CATAWBA NUCLEAR STATION, UNITS 1 AND 2  
DOCKET NOS. 50-413 AND 50-414 / RENEWED LICENSE NOS. NPF-35 AND NPF-52

**SUBJECT: APPLICATION TO REVISE TECHNICAL SPECIFICATIONS TO ADOPT  
TSTF-545, REVISION 3, "TS INSERVICE TESTING PROGRAM REMOVAL &  
CLARIFY SR USAGE RULE APPLICATION TO SECTION 5.5 TESTING"**

- Attachments:
1. Description and Assessment of Technical Specifications Changes
  2. Proposed Technical Specification Changes (Mark-up)
  3. Proposed Technical Specification Bases Changes (Mark-up) – For Information Only

3.4.2.2 All pressurizer Code safety valves shall be OPERABLE with a lift setting of 2485 psig  $\pm$  1%.

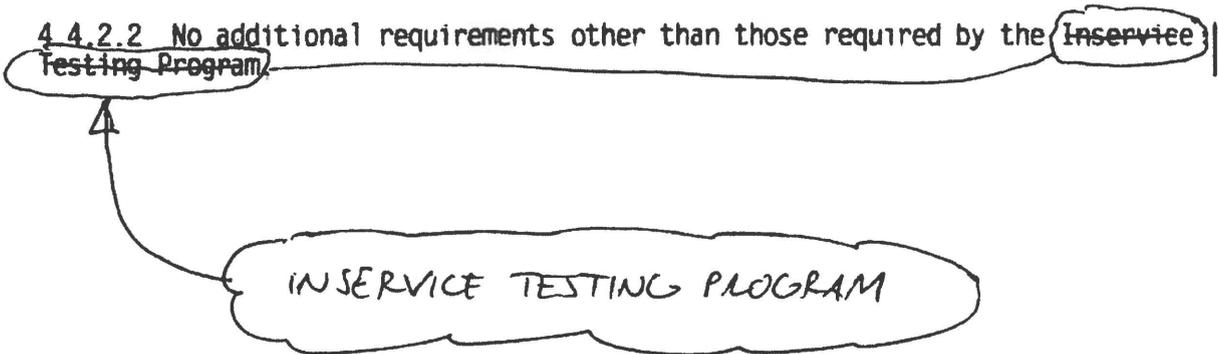
With one pressurizer Code safety valve inoperable, either restore the inoperable valve to OPERABLE status within 15 minutes or be in at least HOT STANDBY within 6 hours and in at least HOT SHUTDOWN within the following 6 hours.

INSERT CNS Bases SR 3.0.3  
(new paragraph)

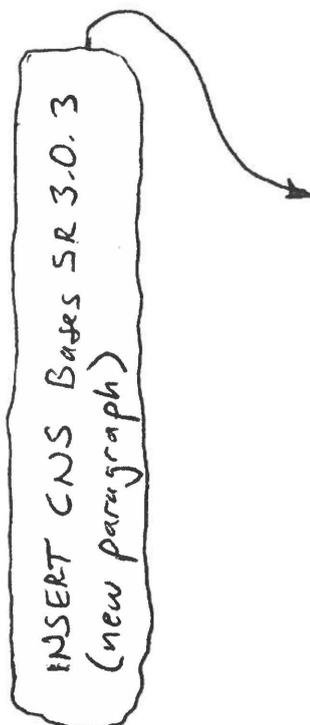
This delay period provides adequate time to complete Surveillances that have been missed. This delay period permits the completion of a Surveillance before complying with Required Actions or other remedial measures that might preclude completion of the Surveillance.

The basis for this delay period includes consideration of unit conditions, adequate planning, availability of personnel, the time required to perform the Surveillance, the safety significance of the delay in completing the required Surveillance, and the recognition that the most probable result of any particular Surveillance being performed is the verification of conformance with the requirements.

SR 3.7.1.1

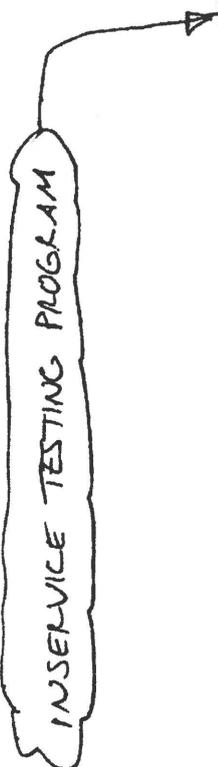
This SR verifies the OPERABILITY of the MSSVs by the verification of each MSSV lift setpoint in accordance with the Inservice Testing Program. The ASME Code (Ref. 6), requires that safety and relief valve tests be performed. According to Reference 6, the following tests are required:

INSERT 1  
ONS Bases 3.0.2  
(new paragraph)

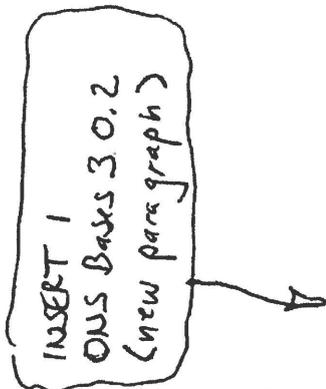
SR 3.0.2 permits a 25% extension of the interval specified in the Frequency. This extension facilitates Surveillance scheduling and considers plant operating conditions that may not be suitable for conducting the Surveillance (e.g., transient conditions or other ongoing Surveillance or maintenance activities).
